SP-150003

Application	General Data	
<p>Project Name: 7-Eleven (Riverdale Park)</p> <p>Location: East side of Baltimore Avenue (US 1) in the southeast quadrant of its intersection with Sheridan Street.</p> <p>Applicant/Address: 7-Eleven, Inc. 1722 Routh Street, Suite 1000 Dallas, TX 75201</p> <p>Property Owner: Friedman Properties, LLC. 10705 Goldwood Court Potomac, MD 20854</p>	Planning Board Hearing Date:	09/10/15
	Staff Report Date:	07/15/15
	Date Accepted:	05/19/15
	Planning Board Action Limit:	Waived
	Plan Acreage:	0.47
	Zone:	M-U-TC
	Gross Floor Area:	2,152 sq. ft.
	Lots:	4
	Parcels:	N/A
	Planning Area:	68
	Council District:	03
	Election District:	19
	Municipality:	Riverdale Park
200-Scale Base Map:	207NE04

TECHNICAL STAFF REPORT:

SUBJECT: **Special Permit Application No. SP-150003
7-Eleven (Riverdale Park)**

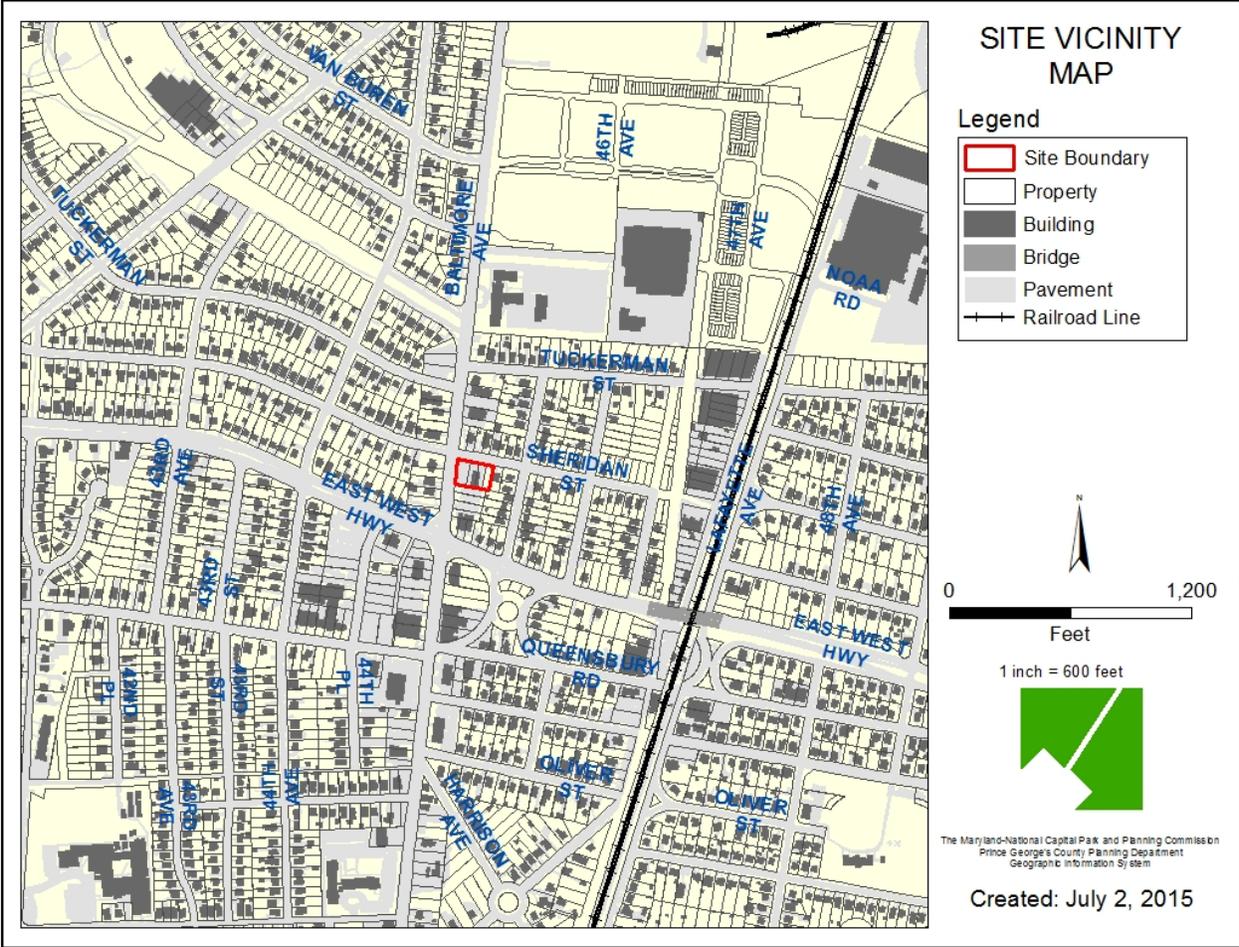
1. Prior to certification of the special permit, the site plan shall be revised as follows:
 - a. Show all of the dimensions of the building footprint, including the dimension of the indentations on the east and west elevations in accordance with the ALTA Survey and field measurements to ensure that the exact size of the alcove and building are correct.

- b. Add a general note on the site plan indicating the existing use.
 - c. Correct the parking note: Maximum parking required is eleven (11) spaces.
 - d. Correct the maximum formula calculation for parking (80% of 1 space/150 SF for the first 3,000 SF = 11).

- e. Provide cut sheets for the lighting fixtures.
 - f. Provide a site plan note indicating that all lighting fixtures are full cut-off luminaires.
 - g. Provide the limit of disturbance on the plans to determine if the project is subject to the tree canopy coverage requirements.

- h. Provide window calculation data on the architectural elevation sheet for the percentage of faux windows and real windows.
 - i. Show the actual uses and zone of the adjacent properties on the site plan.
